**REMARKS**

In the final Office Action, the Examiner objects the abstract under M.P.E.P. § 608.01(b); objects to the drawings as failing to comply with 37 C.F.R. § 1.84(p)(5); rejects claims 1, 3-10, 12-17, and 22-40 under 35 U.S.C. § 112, first paragraph, as failing to comply with the written description requirement; rejects claims 1, 3, 4, 8, 16, 17, 22-26, and 36-40 under 35 U.S.C. § 103(a) as unpatentable over BARHAM et al. (U.S. Patent No. 6,721,371) in view of ENGLISH (U.S. Patent No. 5,489,879); rejects claims 5-7, 13, 27-29 and 33 under 35 U.S.C. § 103(a) as unpatentable over BARHAM et al. in view of ENGLISH, and further in view of QUIGLEY et al. (U.S. Patent No. 6,650,624); rejects claims 14, 15, 34, and 35 under 35 U.S.C. § 103(a) as unpatentable over BARHAM et al. in view of ENGLISH, and further in view of PEYROVIAN (U.S. Patent No. 5,768,682); and rejects claims 9, 10, 12, and 30-32 under 35 U.S.C. § 103(a) as unpatentable over BARHAM et al. in view of ENGLISH, further in view of QUIGLEY et al., and further in view of the applicant's admitted prior art in FIG. 17(A). Applicant respectfully traverses.

FIG. 1B

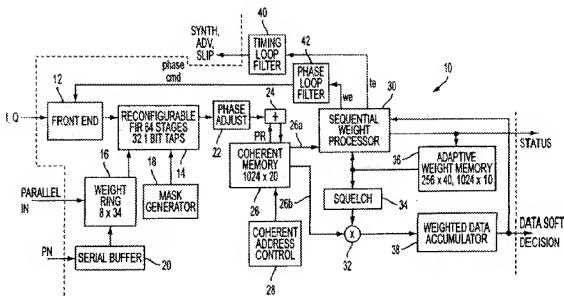
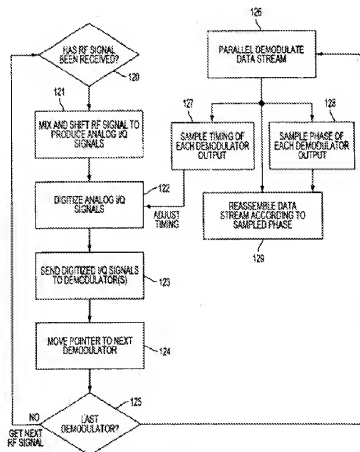
Col. 4, line 11 to col. 6, line 63 of BARHAM et al. generally relate to Figures 1B and 19 (reproduced above) and discloses a high speed demodulator system that includes a number of IC demodulators (RADIS 10) used for acquiring and demodulating radio data communications. Each RADIS 10 is programmable with weight values and may be used to demodulate spread spectrum systems, such as code division multiple access (CDMA) and time division multiple access (TDMA) systems. Received analog signals (I, Q) are digitized by an ADC (step 122 in Fig. 19) and sent to a demodulator (step 123 in Fig. 19). Each RADIS 10 includes a reconfigurable finite impulse response (FIR) filter 14 that is configurable by receiving FIR weights from an external controller (see, e.g., col. 5, lines 31-34 of BARHAM et al.). The FIR filter 14 includes 64 stages implemented with 32 1-bit taps. A set of registers forming a weight stack or ring 16 is connected to the parallel input port for being programmed from the external controller. The output of the weight ring 16 is a set of tap weights which are input to the reconfigurable FIR filter 14. The output of FIR filter 14 is applied to a phase adjustment block 22 and a first input of an adder 24.

This section of BARHAM et al. does not disclose or suggest maintaining (pre-computed) sets of filter coefficients (in non-volatile storage), where each set corresponds to one of the plurality of low-pass digital filters, with each filter having one of a predetermined set of bandwidths, as recited in claim 1. More specifically, the Examiner alleges that the reconfigurable FIR filter 14 of BARHAM et al. somehow corresponds to these features. Applicant respectfully disagrees. Even assuming *arguendo* that ENGLISH may be properly relied on for disclosing maintaining pre-computed sets of filter coefficients in non-volatile storage (a point that Applicant does not concede),

BARHAM et al. still does not disclose or suggest that FIR filter 14 (or RADIS 10) maintains sets of filter coefficients, where each set corresponds to one of the plurality of low-pass digital filters, with each filter having one of a predetermined set of bandwidths, as required by claim 1. In fact, the Final Office Action is completely silent with respect to “sets of filter coefficients” and each filter having one of a predetermined set of bandwidths. The mere fact that FIR filter 14 of BARHAM et al. is disclosed as being configurable, does not disclose or suggest these features.
